RE: Notice of Intent for 8 View Avenue, Sovereign Builders, Inc.  
MADEP File Number 246-0785  
Second Peer Review

**Second Review of Stormwater Management System for View Avenue Condominium Project,  
Northampton, MA**

Enclosure : Hantush Mounding Analysis

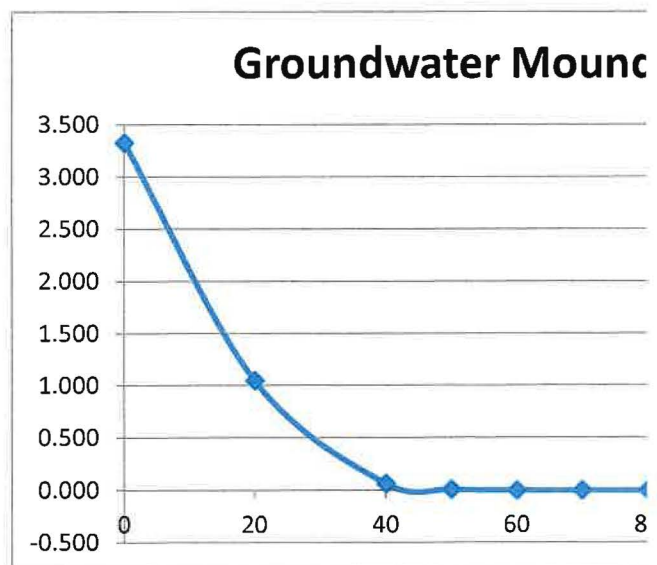
In my opinion, the data input for items (a), (d) and (e) are incorrect for the following reasons.

The Recharge Rate, RR should be based on the total infiltration volume of 823 CF that occurs during the 100-year storm, applied over the footprint of the infiltration area which is 480 SF. This results in a recharge rate of 1.71 feet per day, not the 0.54 feet per day used in the report.

The basin dimensions, even though SIS #2 has an irregular shape, should equate to the actual surface area of the infiltration system, which is 480 SF. The dimensions input in the analysis submitted, 13.86-feet by 9.9-feet equate to an area of 549 SF, overestimating the infiltration footprint by 22 percent. The dimensions should be adjusted to approximately 9.0-feet by 13.3-feet.

Finally, the infiltration duration period should be set to one day, as the model is simulating the response to a 24-hour storm.

Using the parameters discussed above, the Hantush model predicts a groundwater mound at the center of the infiltration system of 3.3 feet. This mound will therefore extend to within the infiltration system.

Mound at center  
 of system = 3.33 feet
